# KOLIN CONTRACT (LOPA COMPOUND)

FORO CONSULTING INC / OCTOBER-10-2025

# **HOUSE 3 - TINAY**

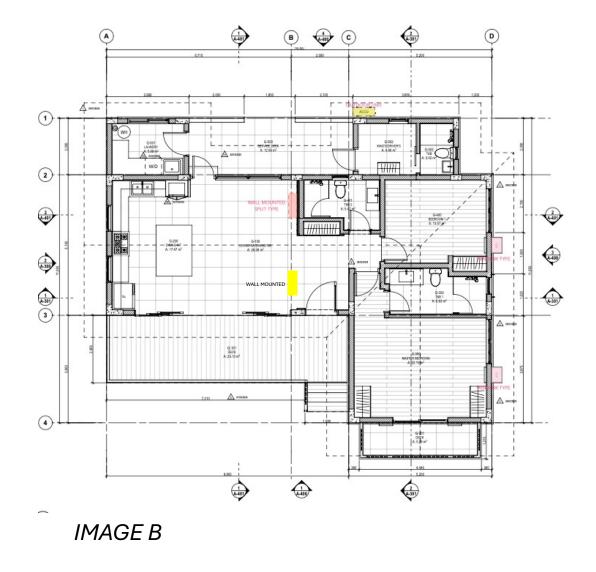
1. Adjust the **indoor unit location** slightly closer to the main door. See **yellow box** in image B for reference.

#### **HOUSE 4 - RAPA**

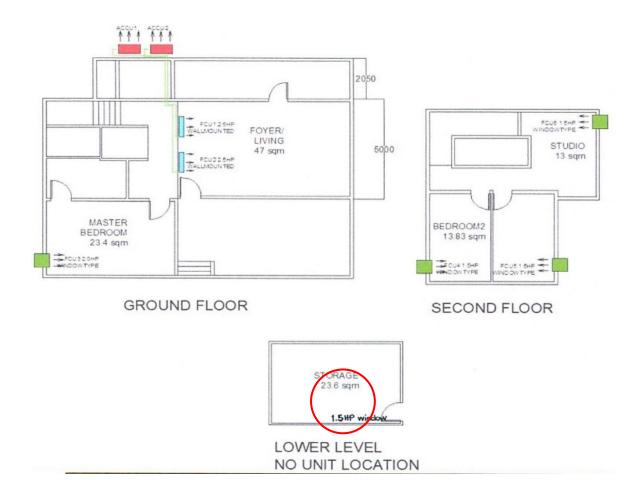
No air-conditioning unit will be installed for the Storage Room.

→ **Provision only** for future ACU installation.

# **HOUSE 6 - JOEL**

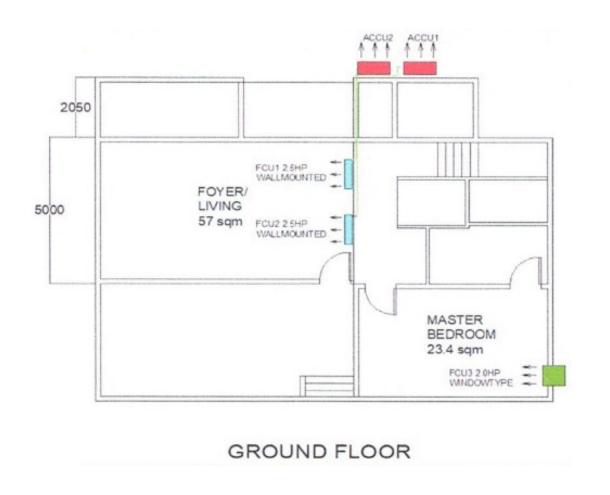
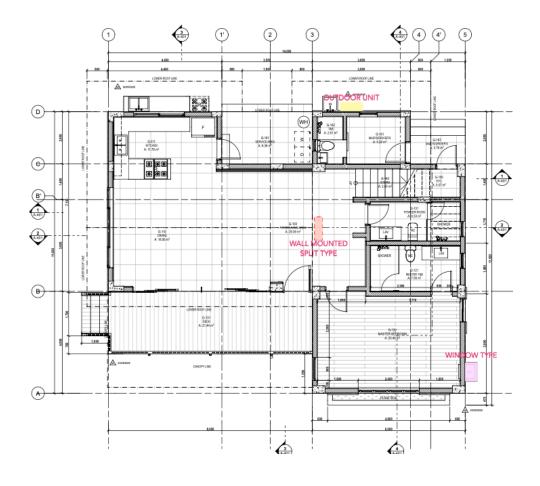
**Verify the plan** being used; it appears **slightly different** from the one provided. Recheck area in the Living.

→ Refer to **Image B** for the correct layout of House 6.

# **HOUSE 7 - NINE**

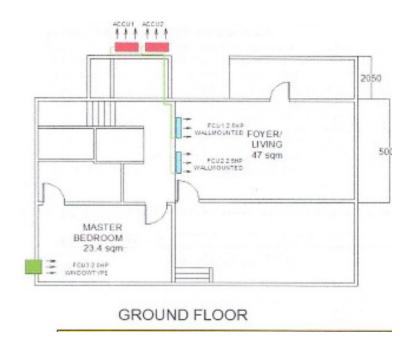
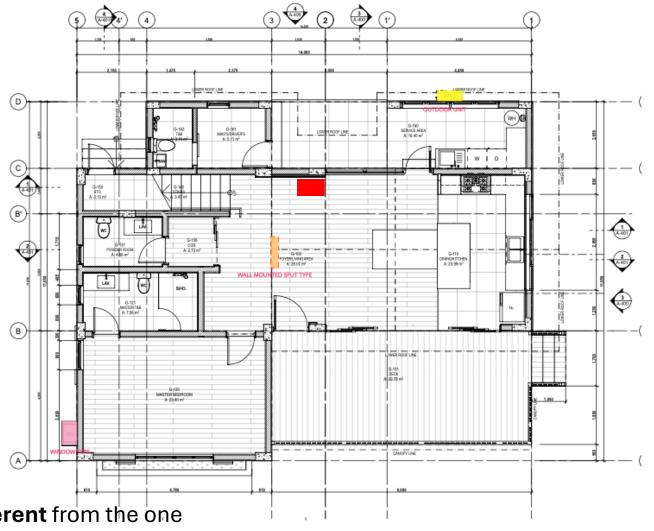
- Verify the plan being used; it appears slightly different from the one provided.
- $\rightarrow$  Refer to **Image B** for reference.
- Change the unit type to **floor-mounted**, location indicated in the red box in *Picture B*.

#### **HOUSE 8 - WHITEY**

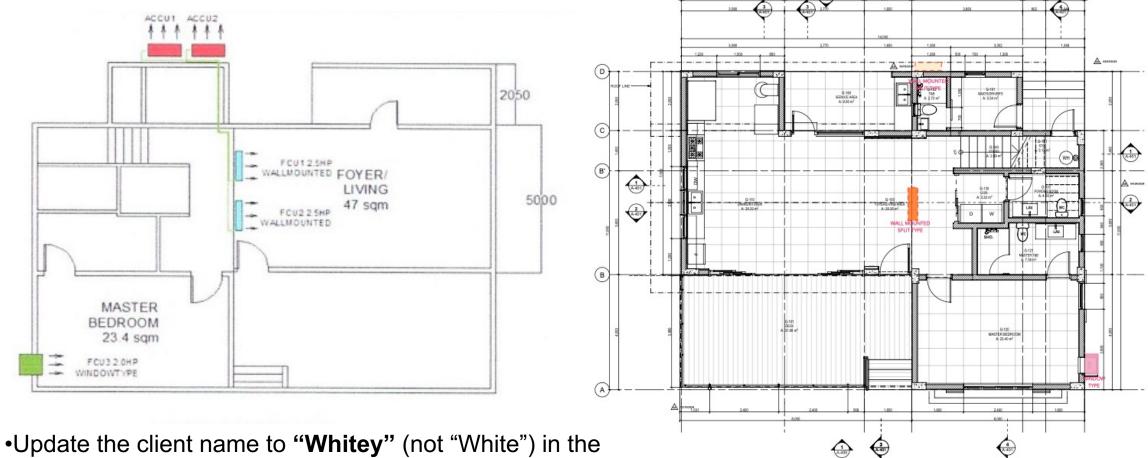
- •Update the client name to "Whitey" (not "White") in the proposal.
- •Verify the plan being used; it appears slightly different from the one provided. Recheck area in the Living.
- → Refer to **Image B** for the correct layout.
